Sydney Metro City & Southwest Chatswood to Sydenham section State Significant Infrastructure Application SSI 15_7400

CKB Consult Pty Ltd

4 OBJECTION SUMMARY

OBJECTION BY CKB Consult Pty Ltd of 9/1-3 GORDON AVENUE CHATSWOOD

The specific reference to our properties is shown below;

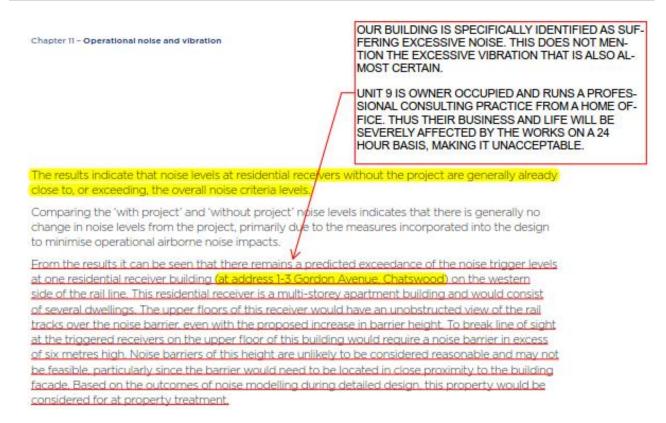
1-3 Gordon Avenue is specifically mentioned in the EIS as an address that will remain affected excessively by operational noise after completion of the work. It further states that it is impractical to create an adequate noise barrier.

The is an inadequate and incomplete reference to "at site mitigation", which implies someone may attempt to make some token sound proofing at the building, but not until after operation commences, and on an "ad hoc" basis. It is unclear who will be responsible, and police the process. As stated earlier, the EPA Railway Noise document is only a non-compulsory and unenforceable "guideline". The operators may deem the situation is satisfactory or beyond their own definition of "reasonable" control.

- 1. The very close proximity of the works, the ground structure and our building basement and stairwell arrangement will result in vibration being amplified within our premises to excessive levels.

- 3. T1 northbound track is closer to Gordon Avenue unit block increasing the noise and vibration impact.
- 4. New Metro tracks will carry more traffic than the existing T1 tracks did. This volume is in addition to the T1 track traffic which will remain.

- 5. The T1 northbound track is raised in height due to being routed over the dive structure. However, in addition to this the dive structure itself finishes at Nelson Street which requires the T1 northbound track to be supported by a concrete bridge structure. This structure will generate significantly more noise than a closed structure and will also allow rail noise from the Metro tracks to pass through to the Gordon Avenue unit block.

- 6. For upper level units, the elevated T1 northbound trains and additional Metro trains will be noisier.
- Ground vibration is a major concern with the increased volume of rail traffic on the T1 plus Metro lines. This vibration can potentially be amplified through the basement area of 1-3 Gordon Avenue.

In the first instance we insist that our unit is resumed by the Government under a negotiated acquisition. The whole property and some 40-50 residents will be removed from the project objectors, and the project may proceed without interruption.
